## Product Change Notice

New dice replacement for PCB base Seven Segment Display HDSP-HxGx series.

- HDSP-H3G1
- HDSP-H5G1
- HDSP-H1G1

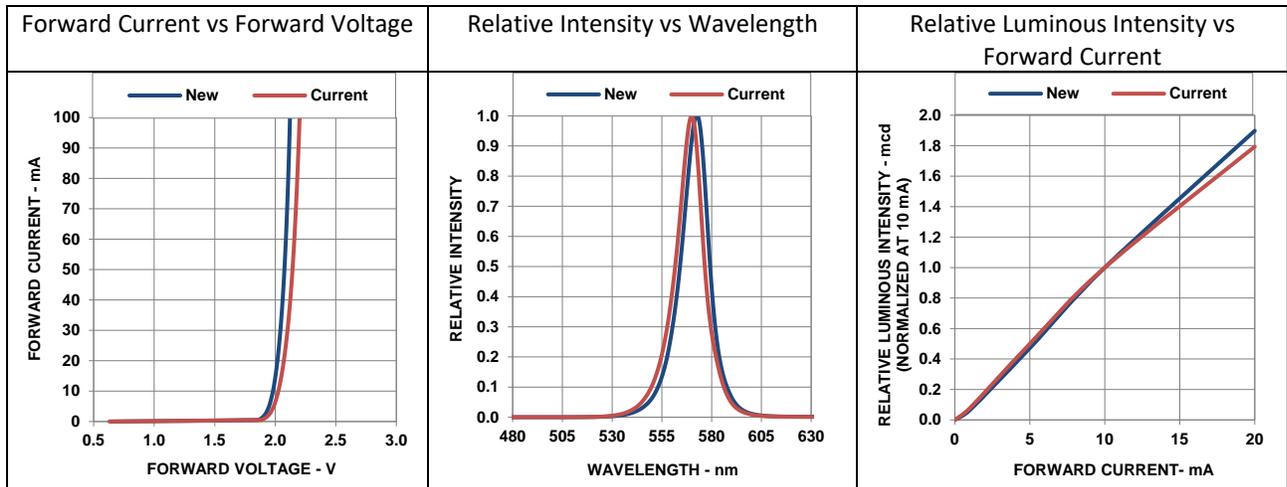
Following are changes in product characteristics:

1. Forward Current vs Forward Voltage
2. Relative Intensity vs Wavelength
3. Relative Intensity vs Forward Current
